UNITED STATES PATENT AND TRADEMARK OFFICE

APPLICATION NO.	FILING DATE	FIRST NAMED INVENTOR	ATTORNEY DOCKET NO.	CONFIRMATION NO.
10/783,897	02/20/2004	John T. Santini JR.	17648-0027	7164

Office Action Summary	Application No. 10/783,897	Applicant(s) SANTINI ET AL.	
	Examiner QUYNH-NHU H. VU	Art Unit 3763

Response to Amendment

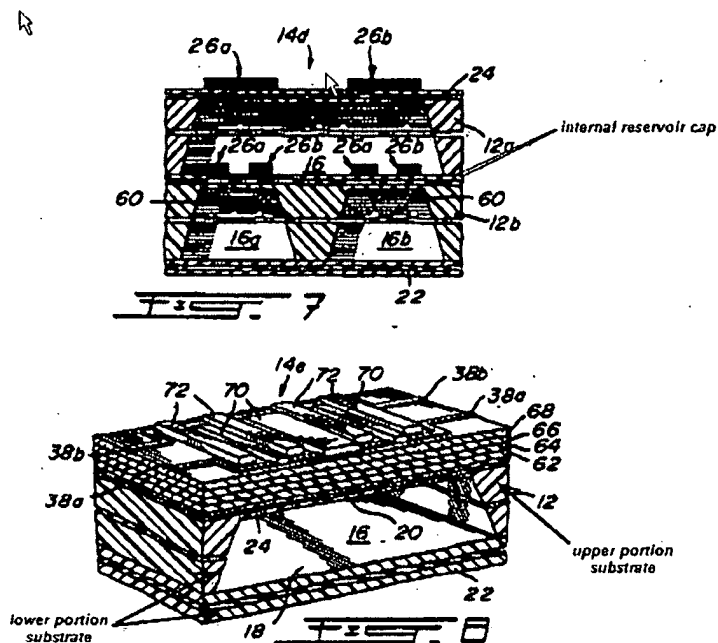
Regarding claim 56, the substrate is comprised of two or more substrate (12 and 22) portion bonded together.

Regarding claim 57, the substrate comprises an upper substrate portion adjacent the reservoir cap and a lower substrate portion distal the reservoir cap (see Fig. 8 below).

Regarding claim 58, as best as understood, wherein a reservoir section in the upper substrate portion is in communication with a reservoir section in the lower substrate portion and the two reservoir sections forming a single reservoir (see Fig. 8 below).

Regarding claim 59, the reservoir section in the lower substrate has a volume that is greater than the volume of the reservoir section in the upper substrate portion.

Regarding claims 57 and 61-62, as best as understood, (Fig. 7 below), the substrate comprises an upper substrate portion 12a adjacent the reservoir cap and a lower substrate portion 12b distal the reservoir cap; wherein the lower substrate portion is provided with an internal reservoir cap interposed between a reservoir section of the upper substrate portion and a reservoir section of the lower substrate portion, wherein release of the molecules from the reservoir section in the lower substrate portion is controlled by diffusion through or disintegration of the internal reservoir cap.
